# HISTORIC AND DESIGN REVIEW COMMISSION

<b>HDRC CASE NO:</b>	<b>2021-637</b>
<b>COMMON NAME:</b>	Fredericksburg Rd (Mary Louise to W Rosewood)
<b>ZONING:</b>	UZROW, H
<b>CITY COUNCIL DIST.:</b>	1
<b>DISTRICT:</b>	Monticello Park Historic District
<b>APPLICANT:</b>	Miranda Garrison/City of San Antonio
<b>OWNER:</b>	City of San Antonio
<b>TYPE OF WORK:</b>	ROW improvements
<b>APPLICATION RECEIVED:</b>	December 01, 2021
<b>60-DAY REVIEW:</b>	Not applicable due to City Council Emergency Orders
<b>CASE MANAGER:</b>	Rachel Rettaliata

The applicant is requesting a Certificate of Appropriateness for approval to install new sidewalks and curbing along the west side of Fredericksburg Road from Mary Louise to W Rosewood.

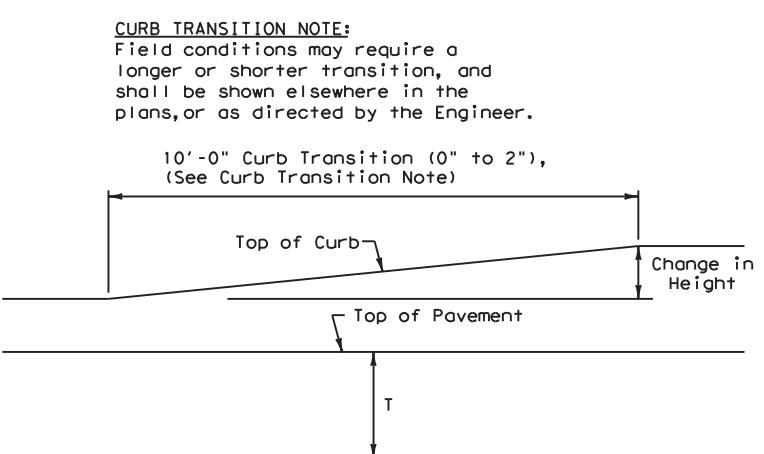
- b. SIDEWALK INSTALLATION – The applicant has proposed to install 6-foot-wide sidewalks and curbing on the west side of Fredericksburg Road between Mary Louise and W Rosewood. Guideline 5.A.iii for Site Elements states that the installation of new sidewalks should follow the historic alignment, configuration, and width of sidewalks and walkways. Alter the historic width or alignment only where absolutely necessary to accommodate the preservation of a significant tree. Additionally, Guideline 5.C.i for Site Elements states that historic curbing should be retained wherever possible. Historic curbing in San Antonio is typically constructed of concrete with a curved or angular profile. Staff finds the proposal generally appropriate, and that the applicant should provide dimensions for the proposed sidewalks.

- c. TREE WELL REMOVAL – The applicant has proposed to remove one tree and tree well located to the east of the property at 2031 Fredericksburg. Guideline 3.D.i for Site Elements states that existing mature trees and heritage trees should be preserved and protected from damage. Staff finds the proposal appropriate.

- i. That the historic curbing is retained and any curbing that requires replacement matches the existing in material, width, and profile.
- ii. ARCHAEOLOGY – The project shall comply with all federal, state, and local laws, rules, and regulations regarding archaeology, as applicable.
